Colman Dock

Meeting Summary

July 18, 2019

Design Development

Figure 1: View of south end of terminal building

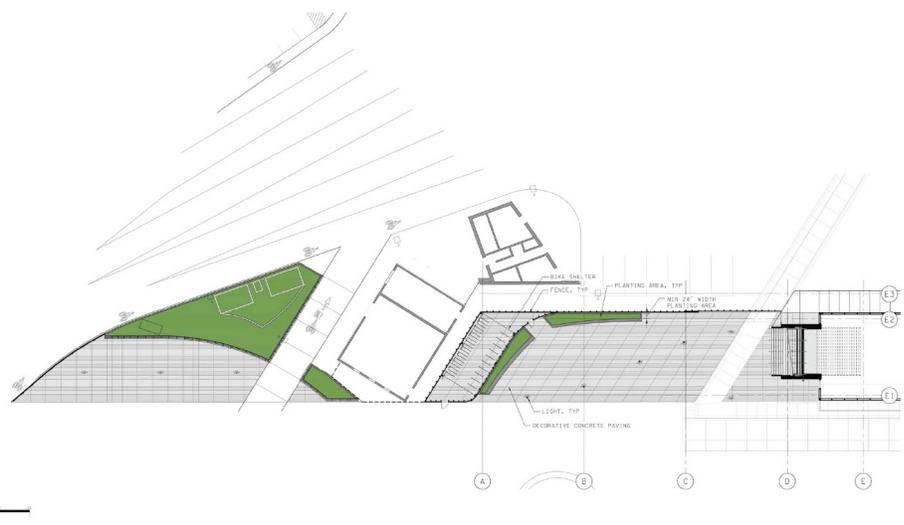
The SDC commended the project team for maintaining the building's architectural character and strong street edge along Alaskan Way throughout the design process. Commissioners also appreciated how the integration of glass along the upper level of the south end of the terminal building increased the sense of openness and visibility along that façade. The Commission then commented about the location of the main entry point near the seismic joint and strongly recommended the project team focus on the materiality of the seismic joint, specifically considering pedestrian safety and access when specifying material.

1. Give attention to materiality of seismic joint
2. Study circulation between 1st Ave and terminal building along the Marion St Bridge; provide information about how circulation will occur when the terminal building is not open
3. Further study how lighting can activate the plazas; Better understand how the poles will function in day time as well as night time
